# MONITORING YEAR 6 ANNUAL REPORT

## LITTLE PINE III STREAM AND WETLAND RESTORATION PROJECT

RE: Monitoring Year 6 (MY6) Report – Draft Submittal  
Little Pine III Stream and Wetland Restoration Project  
DMS Project Number 94903  
Contract Number 6844  
New River Basin - CU# 05050001 - Alleghany County, North Carolina

Wildlands Engineering, Inc. (Wildlands) has reviewed the Division of Mitigation Services (DMS) comments from the Draft Monitoring Year 6 report for the Little Pine III Stream and Wetland Restoration Project. DMS' comments are noted below in **bold**. Wildlands' responses to those comments are noted in *italics*.

Figure 2 Project Component/Asset Map  
 Little Pine III Stream & Wetland Restoration Project  
 DMS Project No. 94903  
 Monitoring Year 6 - 2021

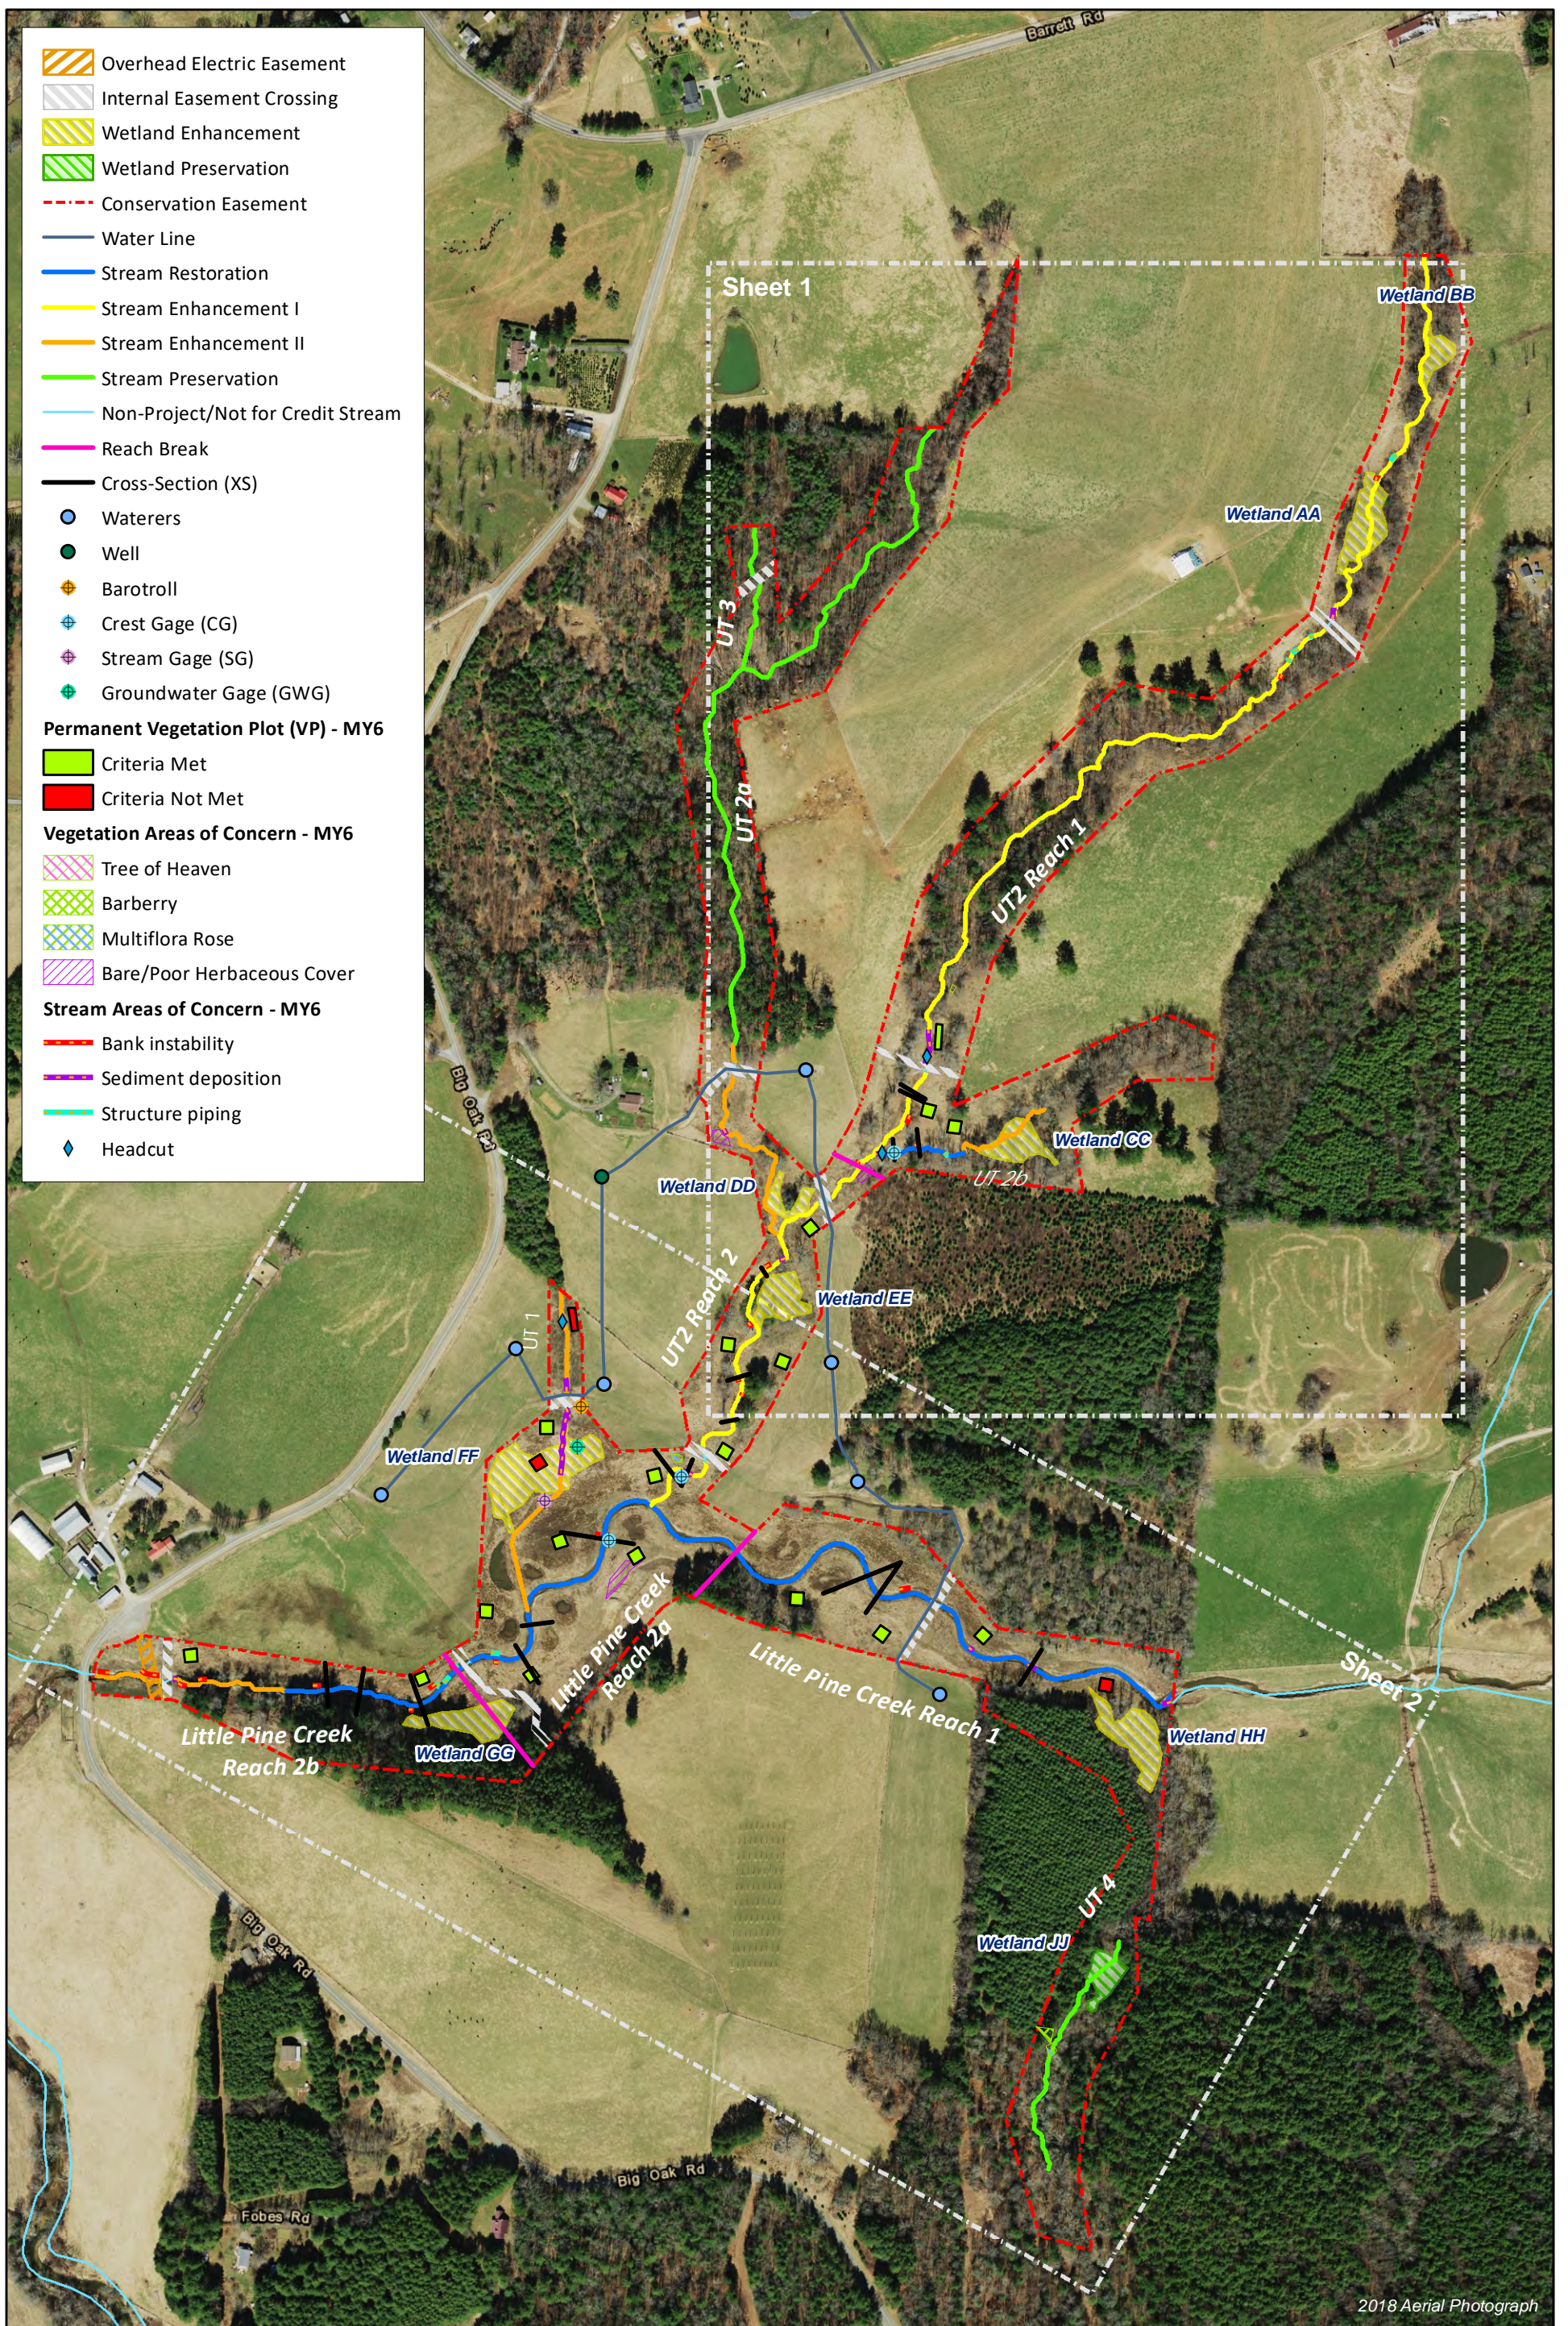
**DMS comment: Aerial photos appear washed out/yellow on the hard copies. Please remove any opaque filtering and/or improve the print quality**

*Wildlands response: The transparency for the aerial imagery has been reduced to 0% to improve the image quality in Figures 2 & 3.*
